Service bulletin T18-210

Fault "5080" on slewing variable speed drive ACS880

GME and GMA

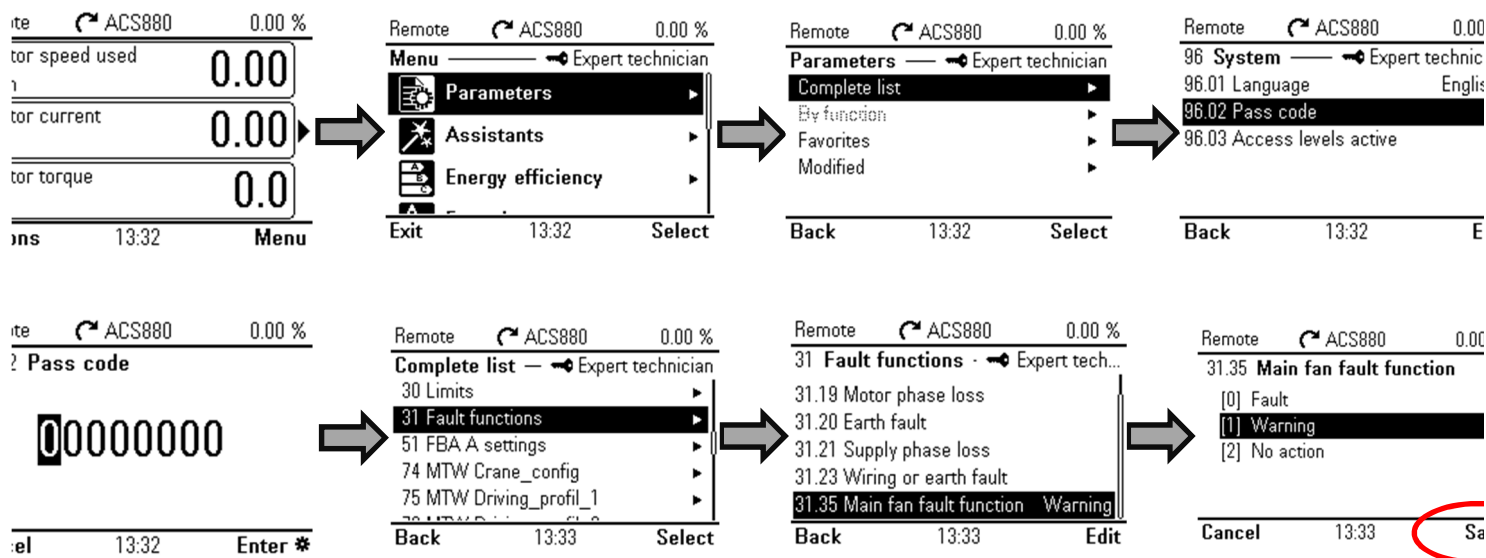
In order to improve troubleshooting of the fan, monitoring based on the measurement of the fan rotational speed has been implemented in the variable speed drive ACS880, but this may prove too sensitive at times.

If the variable speed drive displays a fault with the code "5080" although the fan seems to be working fine, this monitoring may be adjusted to trigger an alarm instead of a fault. Under these conditions, the thermal protective devices will continue to protect the variable speed drive.

To unlock the variable speed drive, enter the "technician" code in 96.02.
Select "alarm" in parameter 31.35 [Main fan fault function], then save.
